Project	IEEE 802.16 Broadband Wireless Access Working Group < http://ieee802.org/16 >		
Title	A new method to enhance the network entry and re-entry procedures in PMP mode		
Date Submitted	2004-11-02		
Source(s)	Chi-Chen Lee Ming Lin Yang Industrial Technology Research Institute, Computer and Communications Research Labs, Taiwan Bldg. 11, 195 Sec. 4, Chung Hsing Rd. Chutung, HsinChu, Taiwan 310, R.O.C.	Tzu- Yu-Ren	Voice: 886-3-5914579 Fax: 886-3-5829733 mailto:jjlee@itri.org.tw mailto:TMLin@itri.org.tw mailto:yryang@itri.org.tw
Re:	IEEE P802.16e/D5-2004		
Abstract	This contribution proposes a new method to enhance the network entry and re-entry procedures in PMP mode.		
Purpose	The purpose of this document is to enhance the network entry and re-entry procedures.		
Notice	This document has been prepared to assist IEEE 802.16. It is offered as a basis for discussion and is not binding on the contributing individual(s) or organization(s). The material in this document is subject to change in form and content after further study. The contributor(s) reserve(s) the right to add, amend or withdraw material contained herein.

A new method to enhance the network entry and re-entry procedure

Figure 130j° – Invited Network Entry° – BS

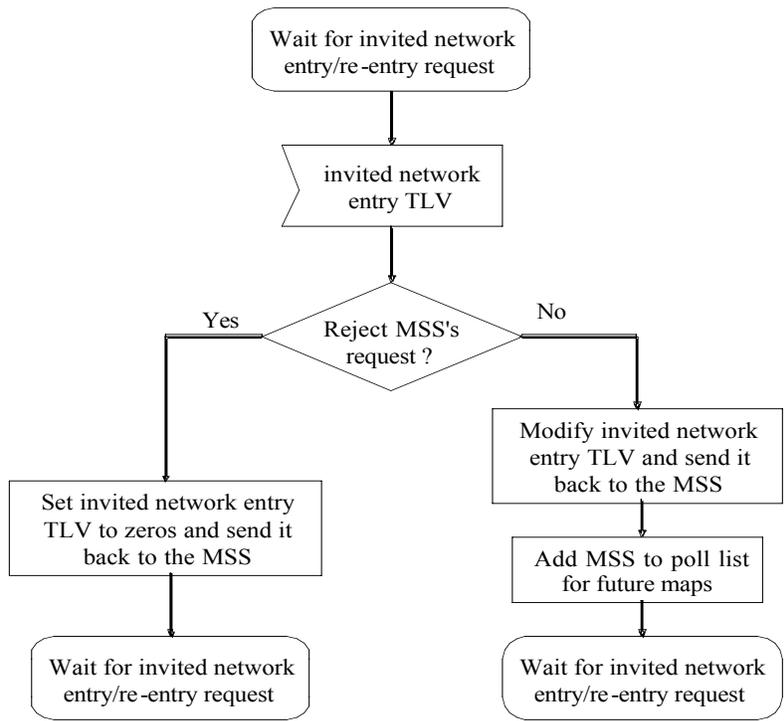
For bandwidth efficiency the BS shall collect those invited BW request opportunities scheduled in the same frame together and places those request opportunities in an PHY specific UL_Extended_IE (UIUC = 15) named Invited_Network_Entry_IE() (see 8.2.1.9.3.7, 8.3.6.3.10 and 8.4.5.4.9). The MSS should not issue contention BW requests unless the Invited BW Request Opportunity Count is exhausted. The BS should schedule the invited BW request opportunity on time. The BS may stop to schedule the Invited BW request opportunity if the invited retries count exhausted. (see Figure 130j, Figure 130k and Figure 130l). The ability of invited network entry is optional for the MSS and mandatory for the BS.
